Docket Number:	15-BSTD-02
Project Title:	Residential Compliance Manual and Documents
TN #:	205481
Document Title:	Comments: VELUX suggested edits to 2016 Residential Compliance Documents
Description:	N/A
Filer:	System
Organization:	Roger LeBrun
Submitter Role:	Other Interested Person
Submission Date:	7/24/2015 10:21:21 AM
Docketed Date:	7/24/2015

VELUX suggested edits to 2016 Residential Compliance Documents

Attached is a combined pdf file containing annotated portions of the proposed 2016 Residential Compliance Manual, and some of the compliance forms, where we noted suggested edits. Adobe Acrobat's "Comment" utility was used to mark-up the downloaded CEC pdf files directly, prior to combining them.

Figure 3-1 – Slope of a Wall or Window (Roof or Skylight slope is less than 60°)
 Source: California Energy Commission

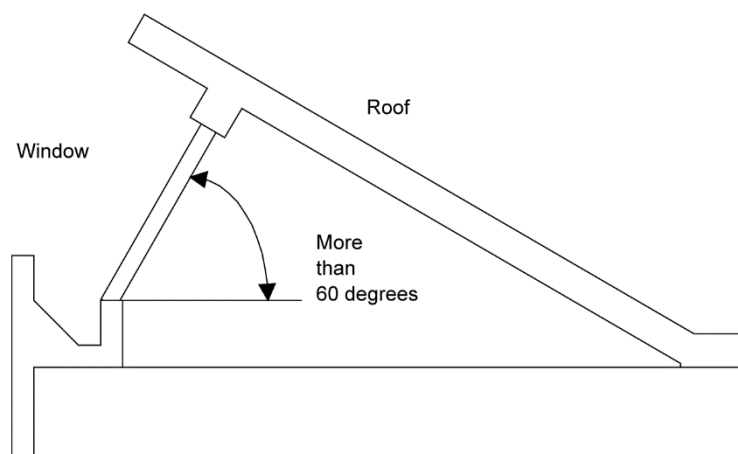
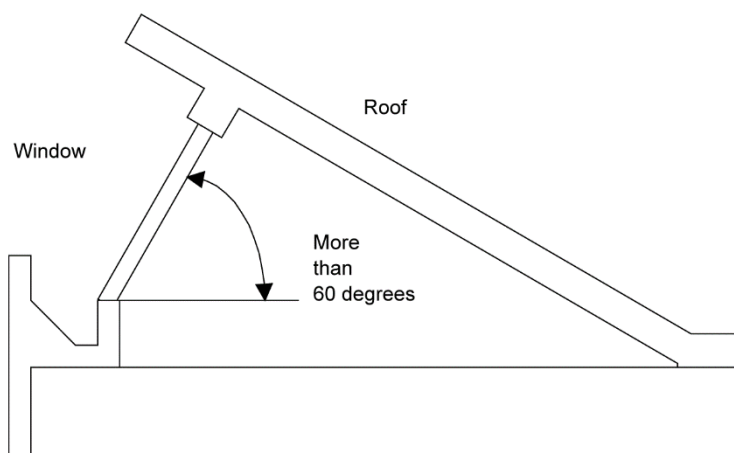
H.D. **Sloping surfaces** are considered either a wall or a roof, depending on the slope (see Figure 3-1). If the surface has a slope of less than 60° from horizontal, it is considered a roof; a slope of 60° or more is a wall. This definition extends to fenestration products, including windows in walls and any ~~skylight types~~ skylight types in roofs.
